CROSSROADS MIXED USE FILING NO. 2

CONSTRUCTION PLANS

TITLE SHEET

V4_CDs Comments.pdf Markup Summary

CENTRAL RAIL POINT & EX SOUTHERN RAIL POINT

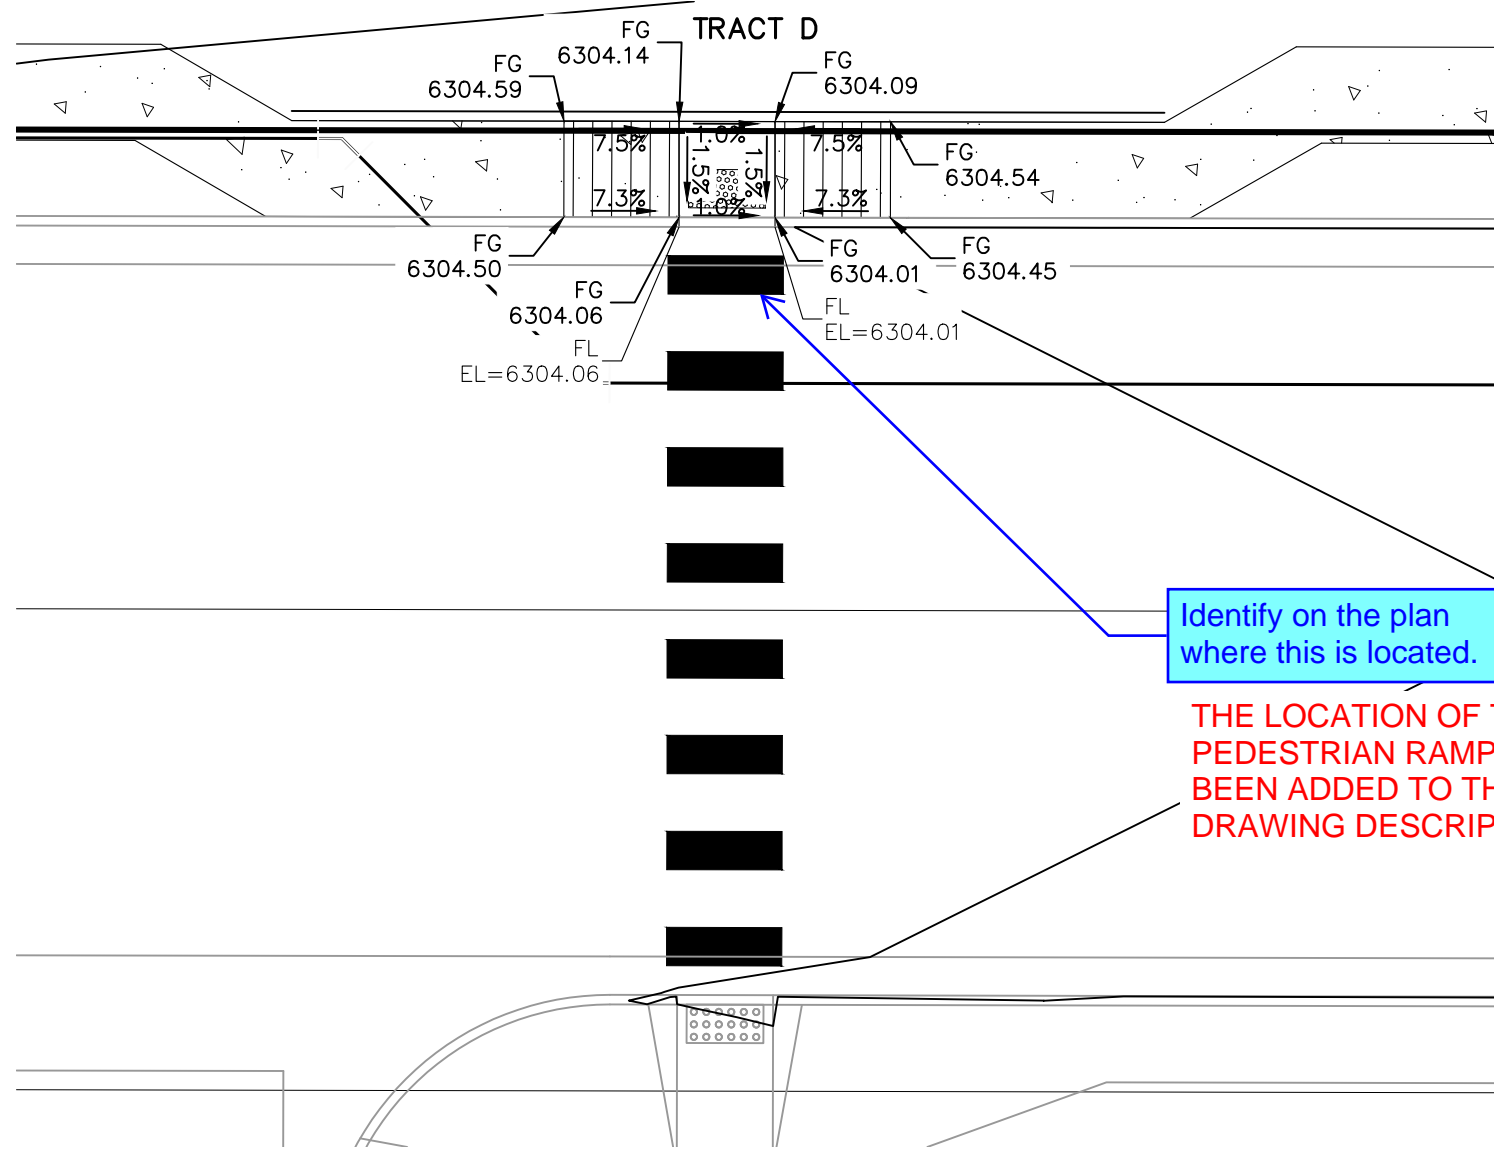
provide truncated
dome

Identify on the plan
where this is located.

THE TRUNCATED DOME
HAS BEEN ADDED.

THE LOCATION OF THE
PEDESTRIAN RAMP HAS
BEEN ADDED TO THE
DRAWING DESCRIPTION.
